NATURESCOT

17 August 2026

## **MORVEN SOUTH OFFSHORE WIND FARM**

### **APPLICATION FOR CONSENT UNDER SECTION 36 OF THE ELECTRICITY ACT 1989 AND MARINE LICENCES UNDER THE MARINE (SCOTLAND) ACT AND PART 4 OF THE MARINE AND COASTAL ACCESS ACT 2009 TO CONSTRUCT AND OPERATE THE MORVEN SOUTH OFFSHORE WIND FARM**

Figure NS.1: Mean MRSea abundance estimates of fulmar as presented in Table D.14 of the baseline characterisation report (Vol 3, Annex 11.1) and Table A.6 of the displacement report (Vol 3, Annex 11.4)

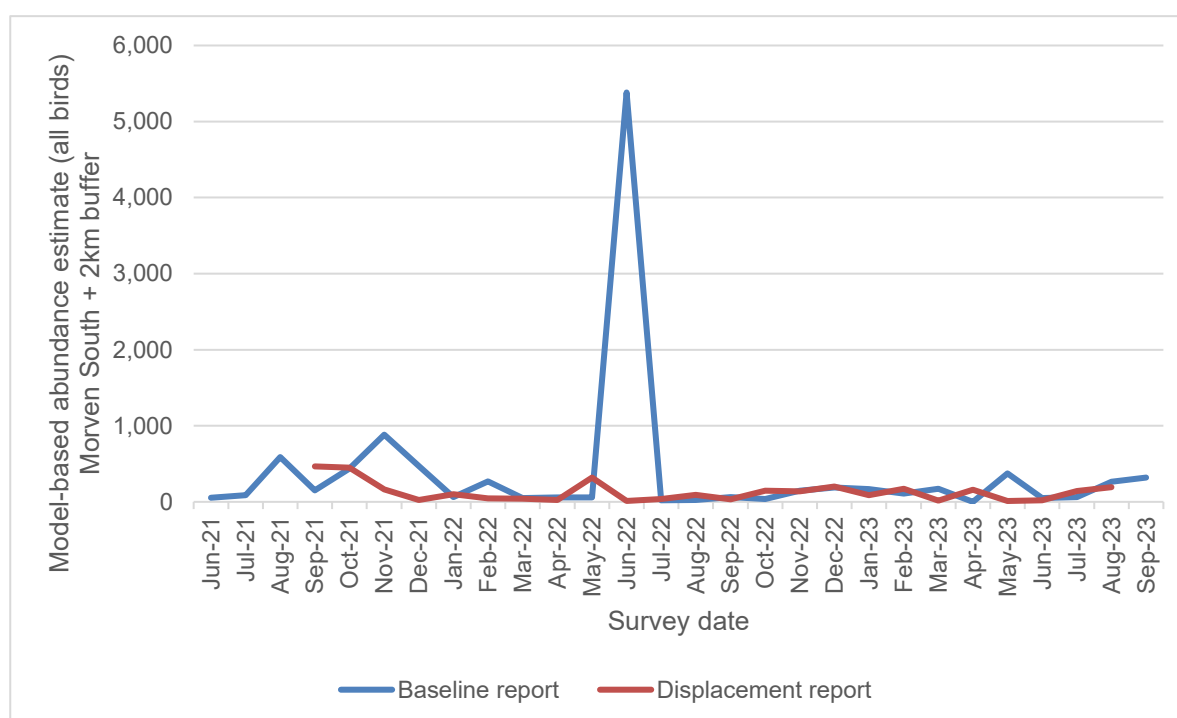
For fulmar, the abundance estimates in Table A.6 (Volume 3, Annex 11.4) are significantly different to those in Table D.14 of the baseline characterisation report (Volume 3, Annex 11.1), with no clear pattern showing the source of the error. A substantial peak of >5,000 birds in June 2022 is reported in the baseline characterisation report, however this is not included for any month in the displacement report where the peak abundance in any month is 466 birds. The mean seasonal peak abundance calculations appear to have been calculated using the monthly abundance estimates in the displacement report in this instance, though the mean seasonal peak abundance estimates still do not match the monthly estimates. We have recalculated the mean seasonal peak abundance estimates and displacement matrix mortality estimates for fulmar, as detailed below in Figure NS.1. Implication of this are discussed in A.4.3.2 below.
